### **NEW DOUBLE DUPLEX FOR: MR. BLOCK AND MR. RHODES** 503 N 8TH AVE UNIT 100 & 503 N 8TH AVE UNIT 200 PENSACOLA, FLORIDA 32501 **ESCAMBIA COUNTY**

# November 2020 Plans

### MINUTES OF THE ARCHITECTURAL REVIEW BOARD

Item 4 714 E. LaRua St. OEHPD / OEHR-2

**A-10**

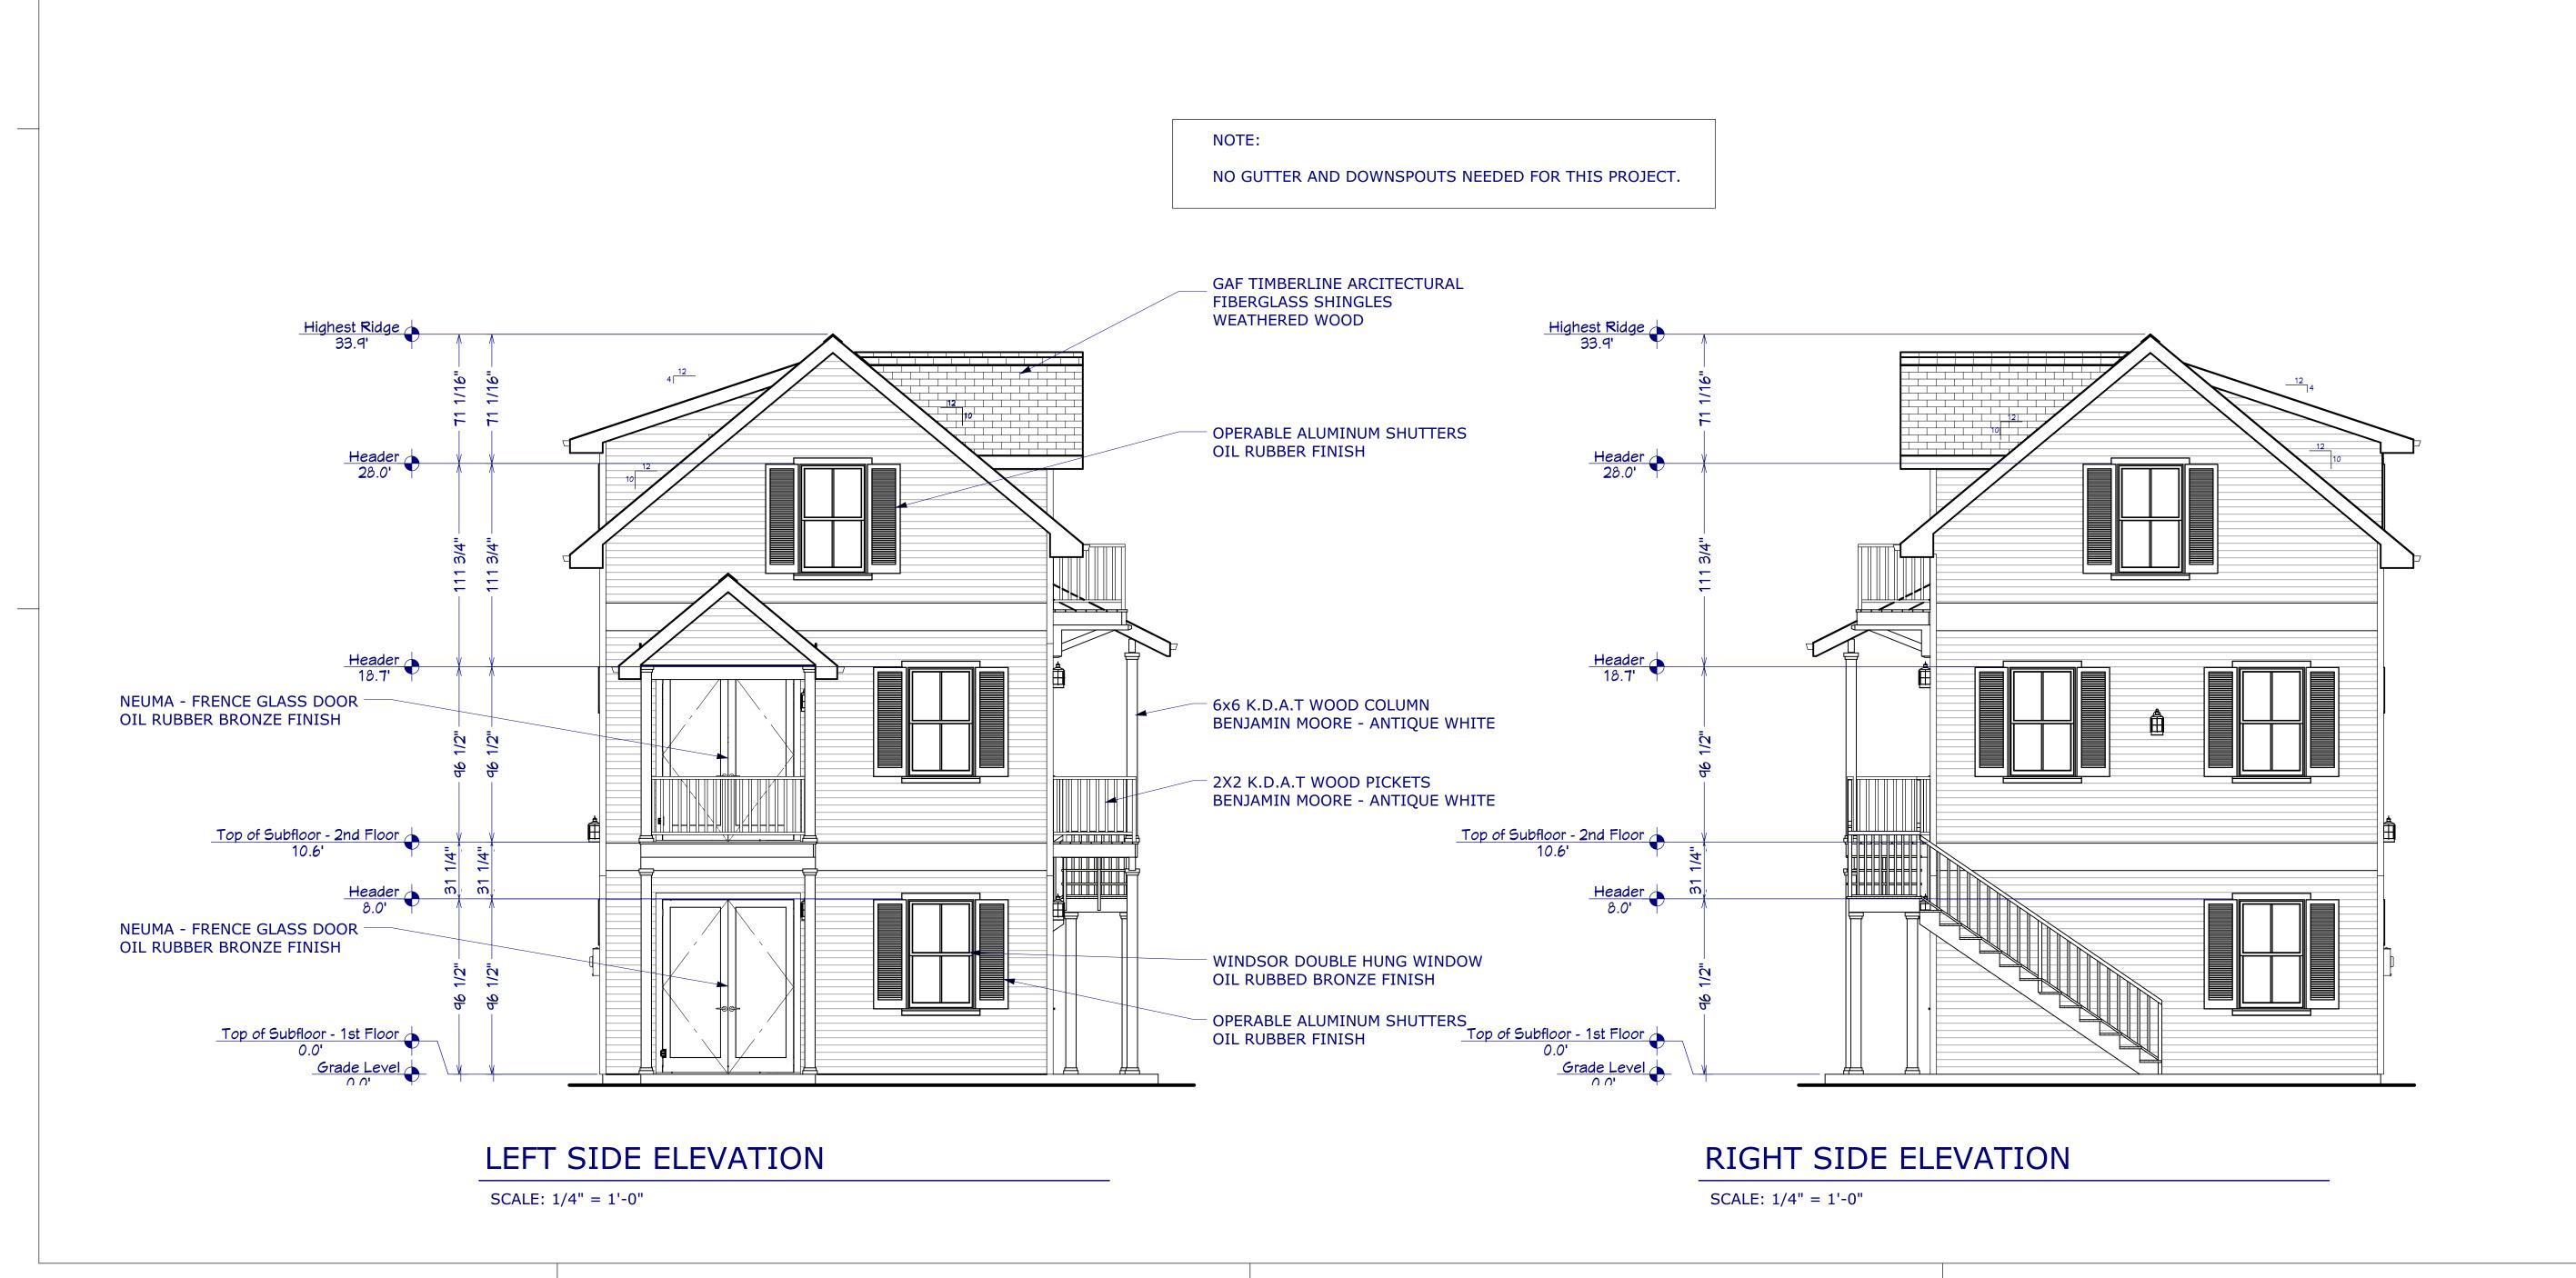
John Schang presented to the Board. Board Member Mead advised when you see these types of accessory structures ancillary to an existing building, a garage apartment is typical, but did not know if he had seen anyone propose a complete duplex as an accessory structure to an existing single family dwelling. Staff advised the use in this district allows for a multi-family commercial use physically, so the duplex seen is not an accessory structure per se, but a full residential duplex that mirrors in with the multi-family use of property. Chairperson Salter advised OEH had expressed concerns about the wall-mounted lighting associated with this building at the second floor level; with these being high for the area, the light would spill over into neighboring properties, and they requested a different type of light be considered – something that directs the light down.

Board Member Mead had questions about the rear elevation. Staff advised the two residences on the neighboring properties to the west might be single-family residences. It was noted the project had been approved by the Board, and what the Board was now reviewing for approval was the design changes from July 2019. Board Member Mead stated there was a significant distance between the structure on the side lot line which exposed the structure to the adjoining property and would be visible to the street. He pointed out the proposed revision would provide a very ill-suited atypical elevation with the center paired windows stacked three-high and not in keeping with the architecture in the neighborhood. He understood the uses for the interior, but it was not fitting for the overall character of the neighborhood. Mr. Schang offered they were trying to maintain the privacy of the property owner. Board Member Ramos asked if there was any requirement in OEH that the proposed structure relate to the original. Staff advised new construction was supposed to be built in a manner which is complementary to the overall character of the district but does not have to completely match nearby residences. The Board was

reviewing the project because the changes were not minor and did not fall under the purview of an abbreviated review. Board Member Villegas was inclined to approve what was originally proposed and appreciated the applicant considering the Board's comments, but this revision was so modern, the juxtaposition with the contributing structure would be so extreme, it would not be complementary in any way; she suggested that maybe they should return to the original windows on the lower two floors and allow the French door or dress those French doors with the mullions which would allow it to have that finished window look; this was a completely different project. Board Member Mead suggested there were ways to approach this to make it consistent with the traditional forms, but he could not approve this in its modern form from what the Board previously approved. Board Member Fogarty suggested eliminating the third-floor dormers on both sides of the house which would make a difference in how the overall project reads. Board Member Ramos suggested the historical structure be included in the drawings to give the Board a sense of how the new construction would give or take away from the overall appearance. Board Member Mead explained it needed to be consistent with the surrounding structures. Advisor Pristera indicated the applicant could get inspiration from the west side of the original structure which has a two-story gable that might be in similar size, or possibly consider how the siding is broken up, but it would be hard to match what the use is, and the neighborhood would not typically have a structure with all the doors; there were a lot of things making it challenging, and a gabled two-story would have been simpler in design with a lot less doors and windows. Board Member Ramos stated the overall size of what was proposed was not an issue as much as how it was being treated architecturally which needed more massaging to get it to fit within that neighborhood.

Board Member Mead made a motion to deny the current application for modification, with the existing application remaining approved, and encouraged the applicant to submit with the Board's comments. Chairperson Salter referred to the LDC Section 12-2-10(C)(5)(C)(2)(B) Rules Governing Decisions of the ARB and Section 12-2-10(C) (9) Regulations for New Construction OEHPD stating that new construction should not be detrimental and that it should fit into the character of the district which was the general consensus of the conversation. Board Member Mead asked that his motion incorporate the citations to the provisions that the Board was relying on as stated by the chair. The motion was seconded by Board Member Villegas, and without any speakers carried unanimously.
